SUBJECT : ACU Software Version 2.1

PURPOSE : To add maintenance capability and operational enhancements for the ASOS

EQUIPMENT AFFECTED: ASOS

FIELD MODIFICATION KIT - ASOS SOFTWARE VERSION UPGRADE

FIGURE 1. AGL MEMORY BOARD ERROR LOCATIONS

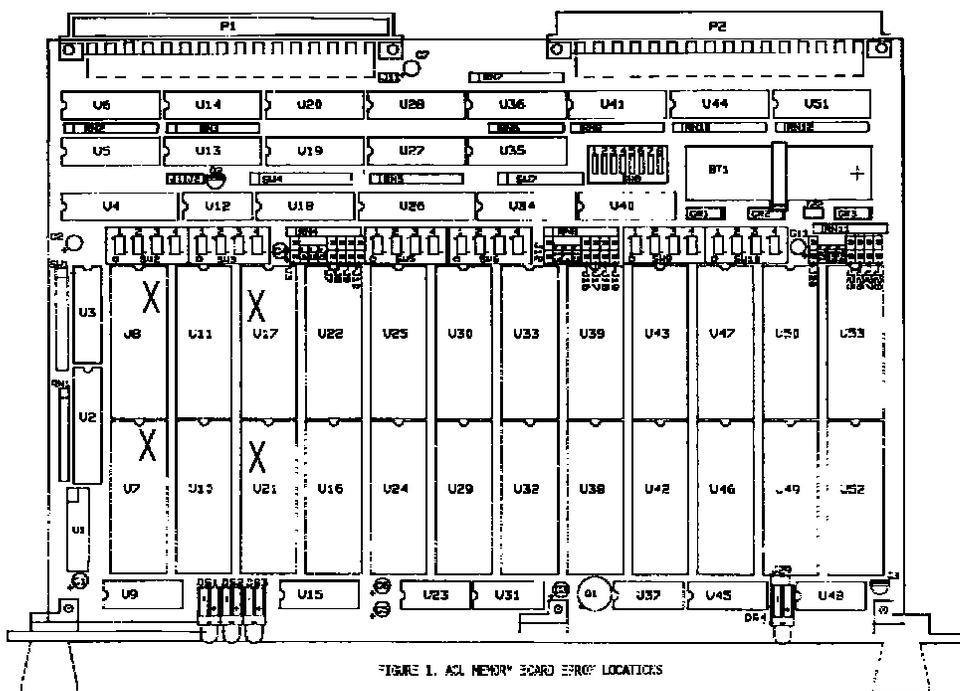
All ASOS application software is contained on four erasable programmable read only memory (EPROM) integrated circuits (IC) on ACU memory board 1A2A3. Figure 1 illustrates the ACU memory board and identifies the four EPROMs (U8, U17, U7, and U21). The EPROMs are 32-pin dual in-line package (DIP) CMOS devices, each providing 512K x 8 bits of storage. Upgrading ASOS software requires only replacing the four EPROMs on the ACU memory board with higher revision level ICs.

4. Using IC insertion tool, remove new EPROM integrated circuits from protective packaging and insert into ACU memory board sockets in accordance with the following chart. Ensure that EPROMs are installed with pin 1 (as identified by notch in top of IC) oriented toward board connector P1 as shown on Figure 1.

U8	62828-45002-1
U17	62828-45003-1
U7	62828-45004-1
U21	62828-45005-1
